Service Bulletin

Ref. No. **COM-0218 (B056)**

Subject	Note when releasing the paper jam/maintaining the machine (Prohibition of use of the flammable sprays and liquids)
Model	All models

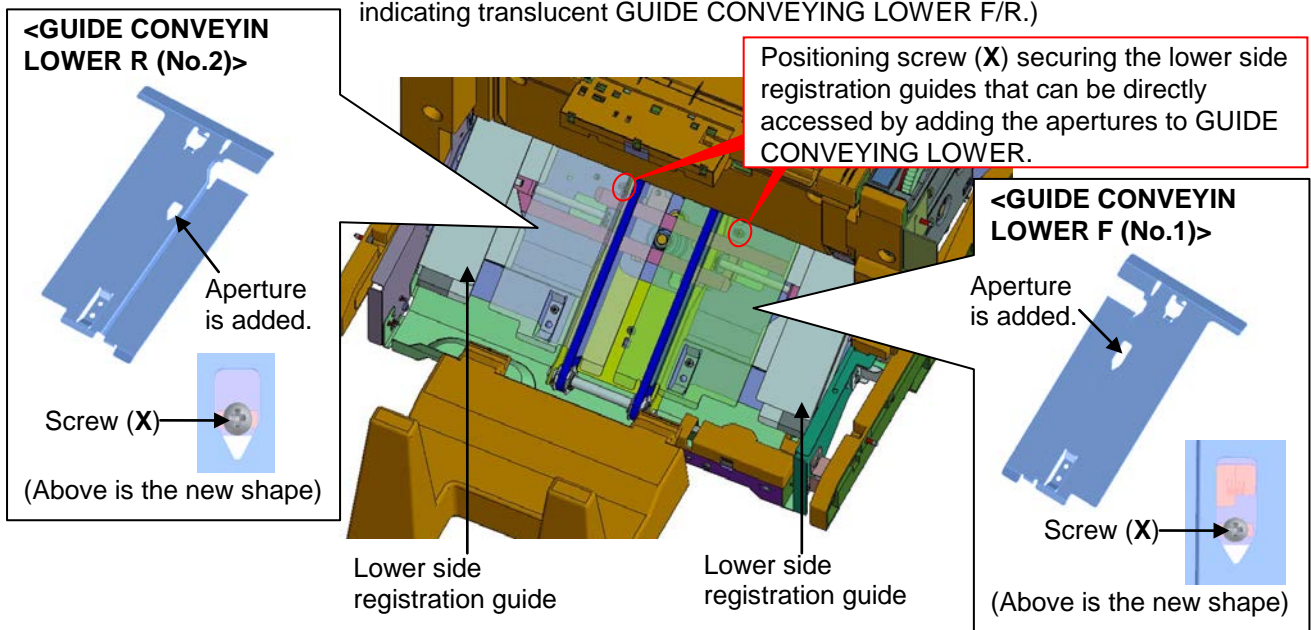
Currently, GUIDE CONVEYING LOWER (No.1, 2) needs to be removed for loosening the positioning screw (X) securing the lower side registration guide when adjusting. At this time, its work becomes unnecessary by adding the apertures to GUIDE CONVEYING LOWER (No.1, 2) in order to directly access the screw.

(Below is the state of removing the unrelated parts like the output tray and of indicating translucent GUIDE CONVEYING LOWER F/R.)

(Figure of indicating the positional relation between the upper side registration guide and lower guide)

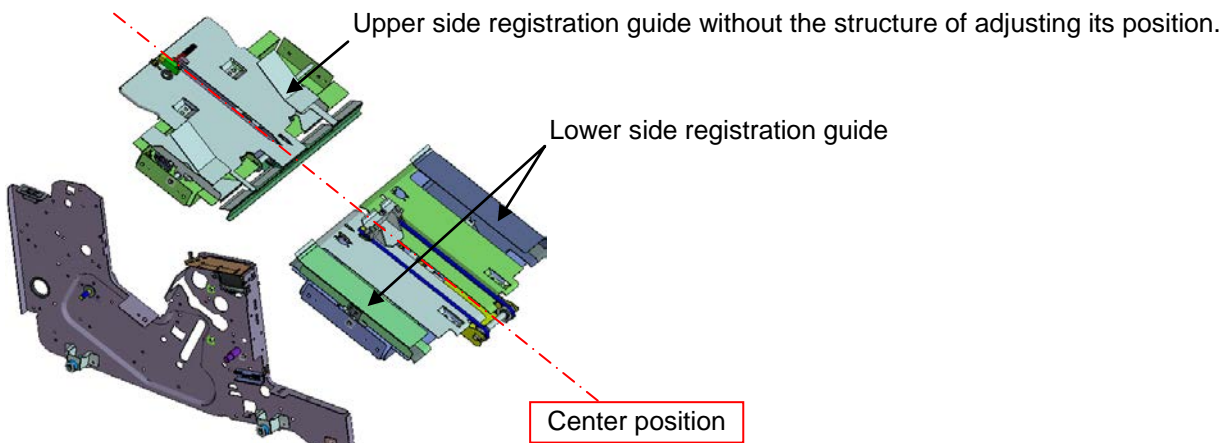
If the center position between the upper side registration guide and the lower guide shifts, the gap of the half-folded paper may be larger. In that case, please adjust the center position of the lower side registration guide in the horizontal direction according to the procedure in the next page and after for aligning it to the center position of the upper side registration guide.

<COVER LEFT UPPER (No.3)>

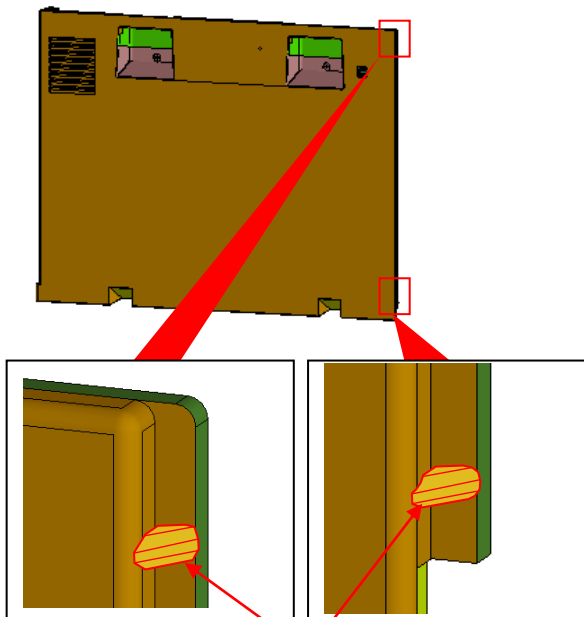
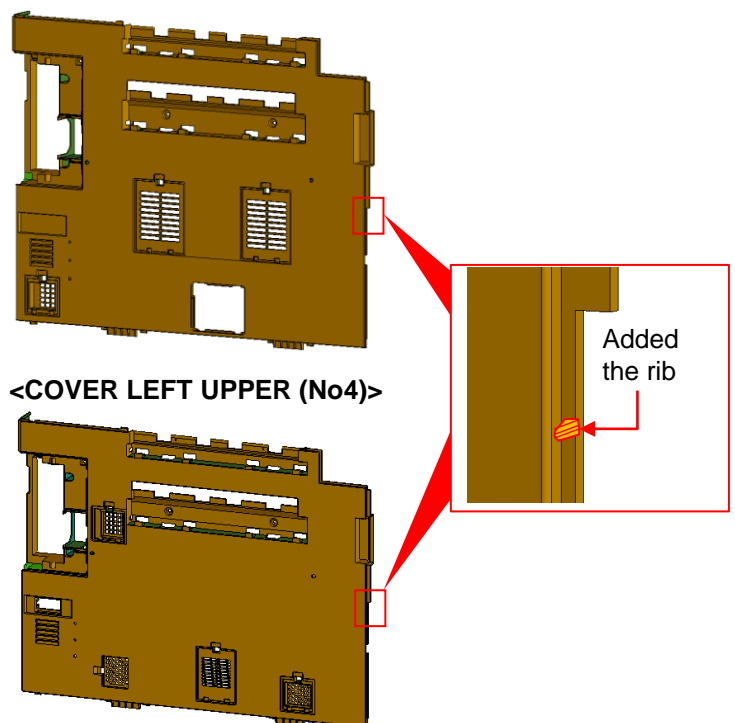
Added the ribs
